SDP-1801

Application	General Data	
Project Name: Bevard East Umbrella Architecture Location: Along MD 223 (Piscataway Road), approximately four miles southwest of its intersection with MD 5 (Branch Avenue). Applicant/Address: Lennar Bevard, LLC 7035 Albert Einstein Drive Columbia, MD 21046	Planning Board Hearing Date:	05/02/19
	Staff Report Date:	04/16/19
	Date Accepted:	02/28/19
	Planning Board Action Limit:	05/07/19
	Plan Acreage:	562.85
	Zone:	R-L
	Dwelling Units:	N/A
	Gross Floor Area:	N/A
	Planning Area:	81B
	Council District:	09
	Election District	05
	Municipality:	N/A
	200-Scale Base Map:	215SE04

STAFF REPORT

SUBJECT: Specific Design Plan SDP-1801
Bevard East Umbrella Architecture

MODEL:
SOMERSET

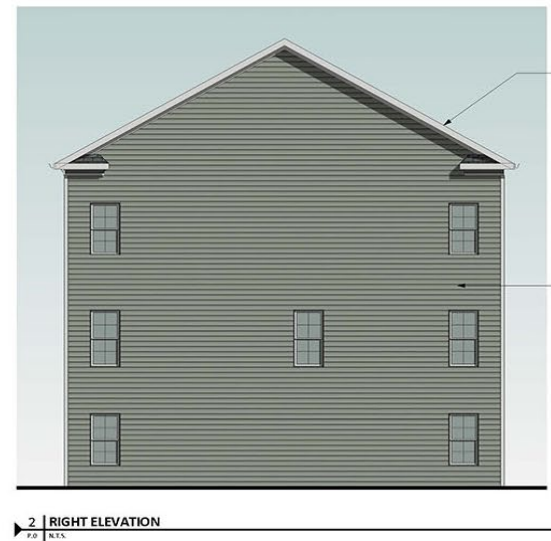
- j. Remove the Fairmount, Portfield, and Somerset models from the SDP or increase their base finished square footage to 2,400.
